REVISIONS			HEADMAN, FERGUSON & CAROLLO FOR CITY OF RIVERSIDE CALIFORNIA DEPARTMENT OF PUBLIC WORKS	
MARK	DATE	DESCRIPTION	APPROVED BY	
△	3/23/51	EXISTING 18" CULV. SHOWN		
△	3/23/51	ADD HEADWALL ELEV.		
△	3/23/51	CHANGE 18" V.C.P. ELEV.		
△	4-2-57	AS BUILT F.R. 603/46/118

DESIGNED BY	G.C.W.	CHECKED BY	W.H.	APPROVED BY	
DRAWN BY	G.C.W.	DATE	MARCH 15 1957	DIRECTOR OF PUBLIC WORKS	5-77
RECOMMENDED BY	<i>James J. Smith</i>	DATE	MARCH 15 1957	ASSISTANT CITY ENGINEER	SHEET 1 OF 1

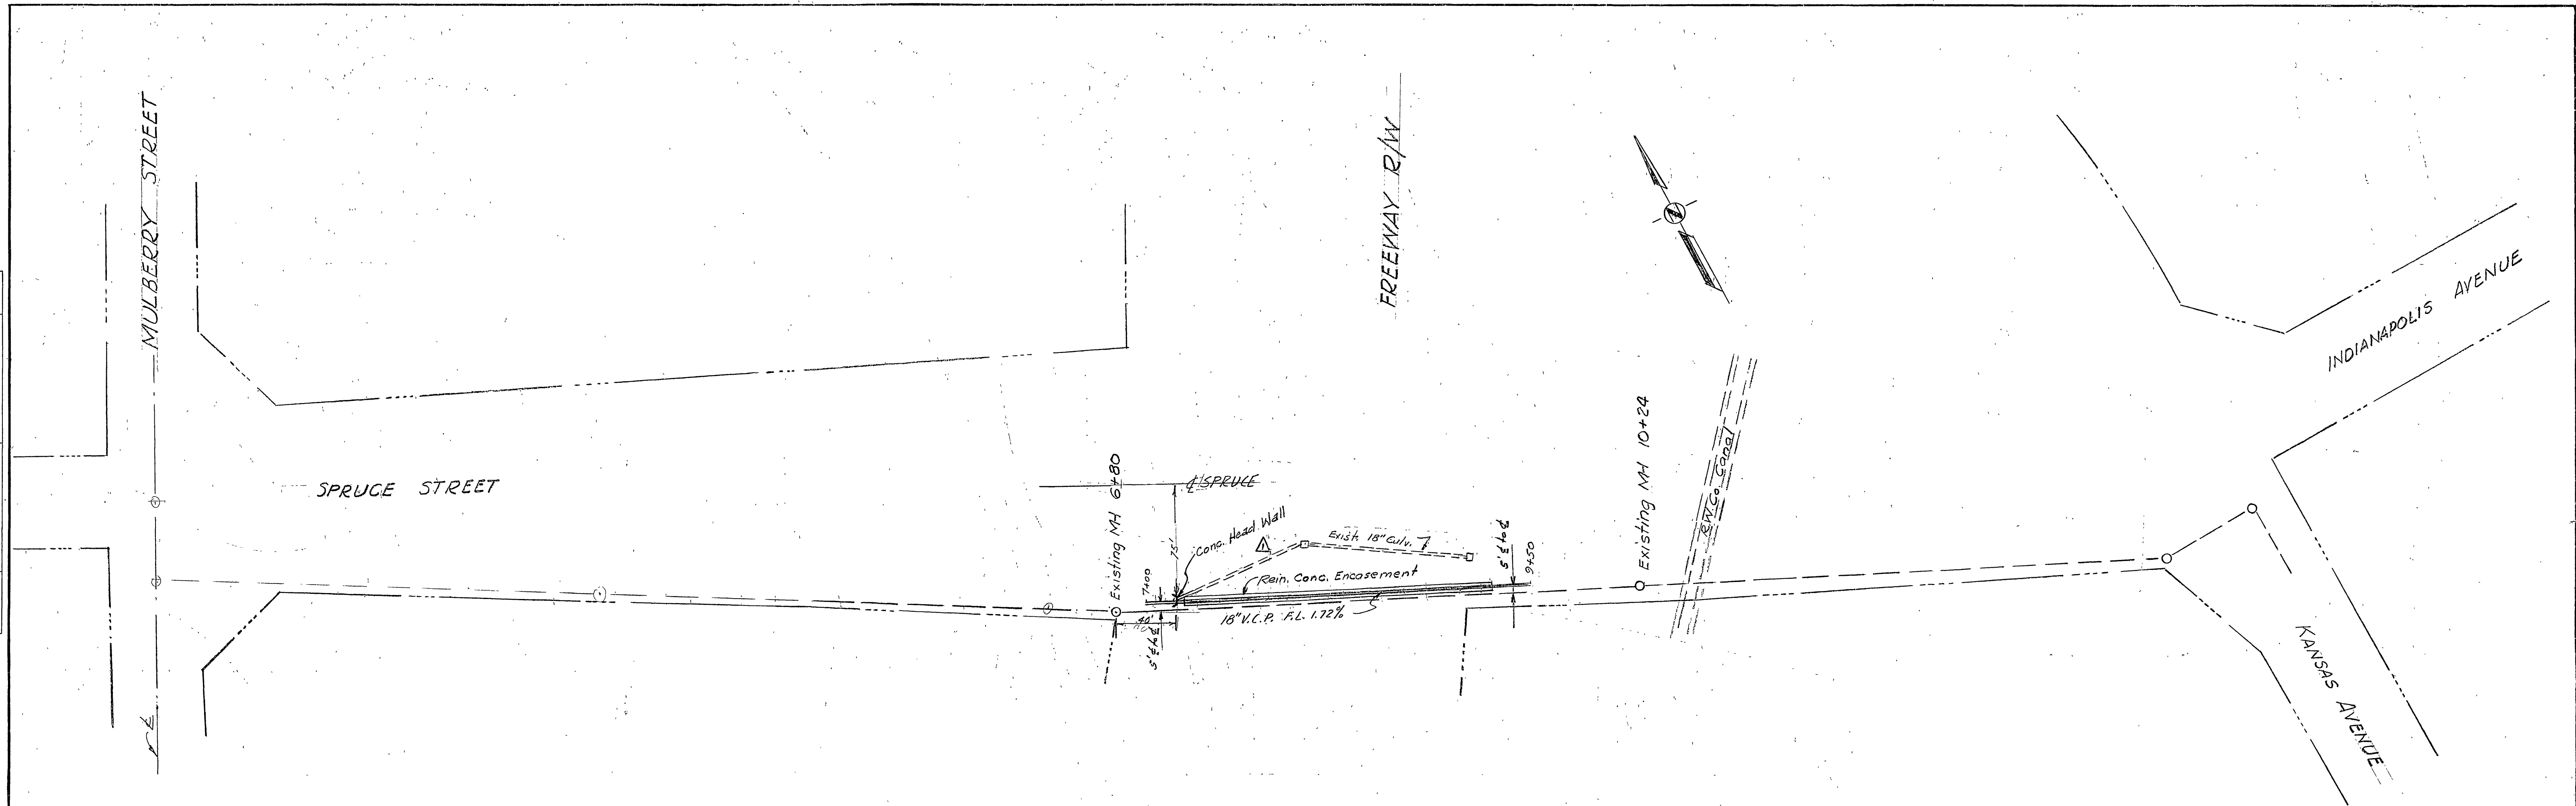
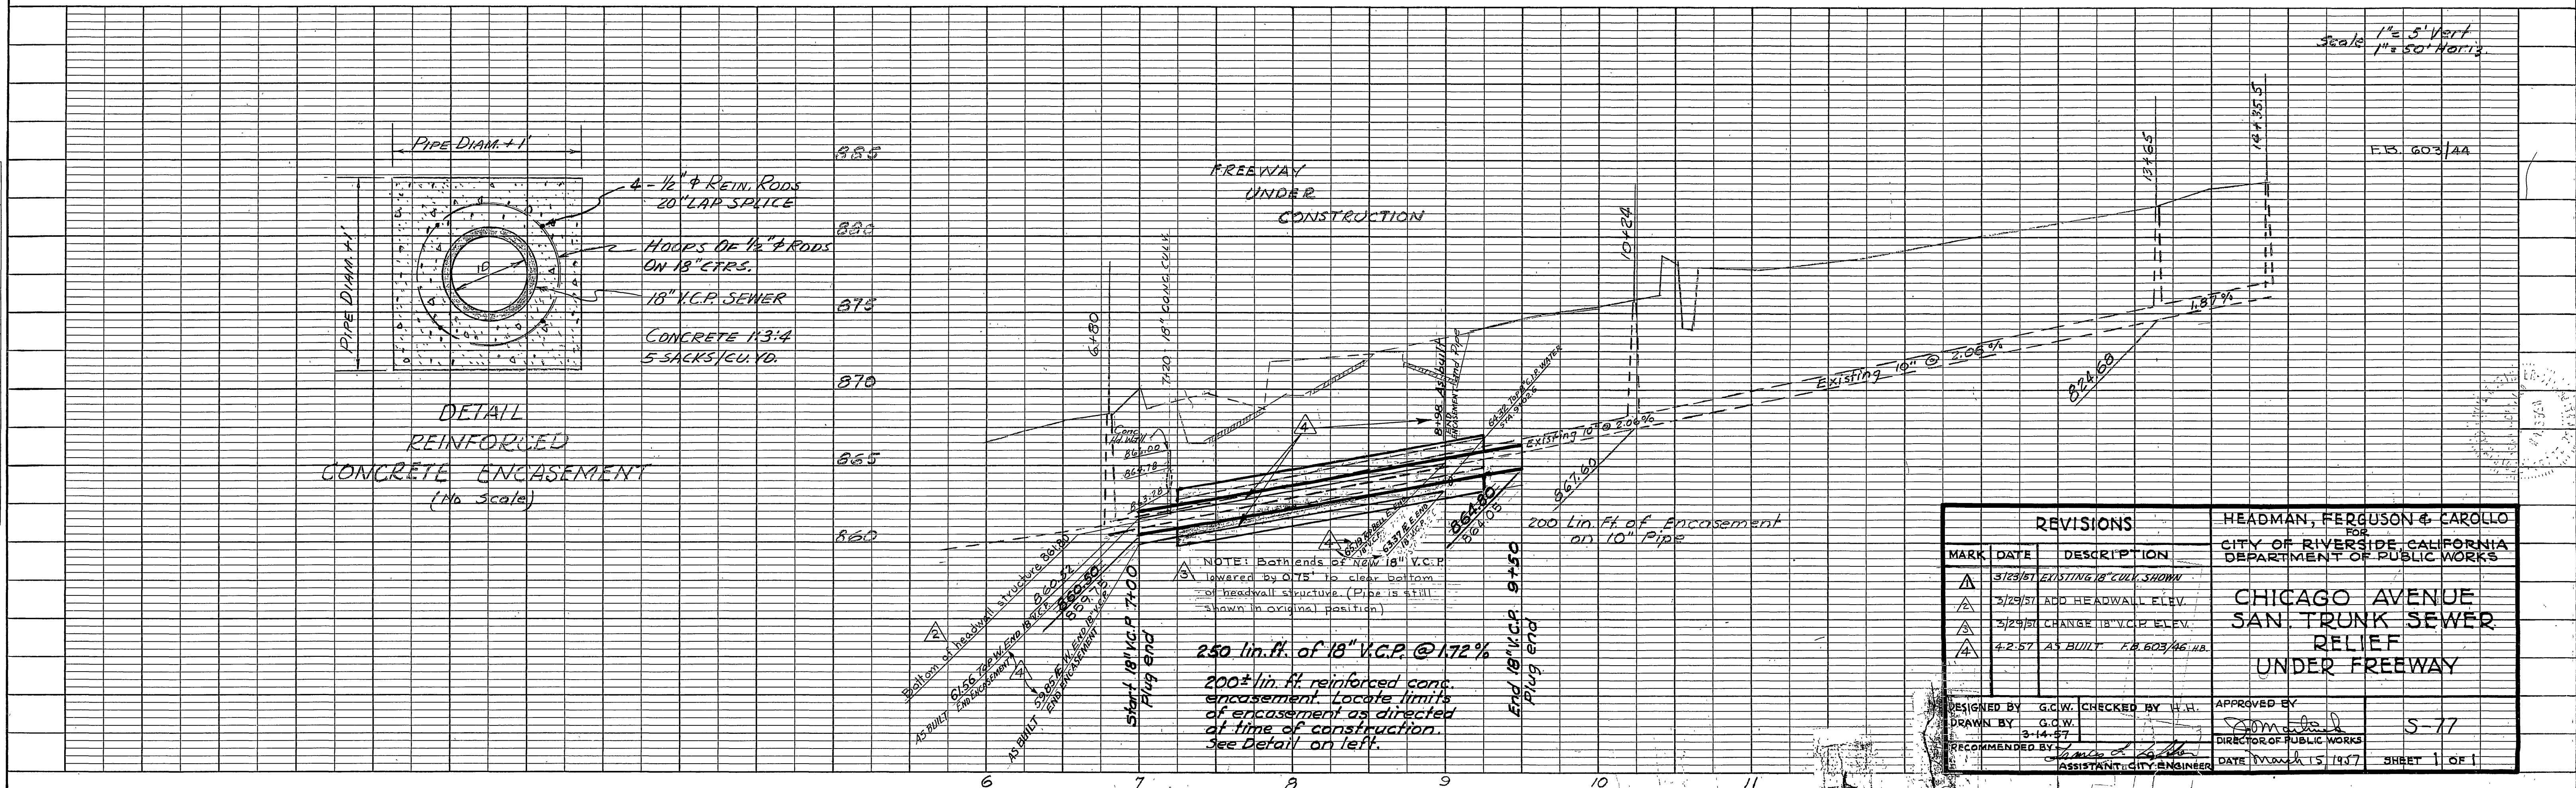
NOTE: Both ends of new 18" V.C.P. lowered by 0.75' to clear bottom of headwall structure. (Pipe is still shown in original position.)
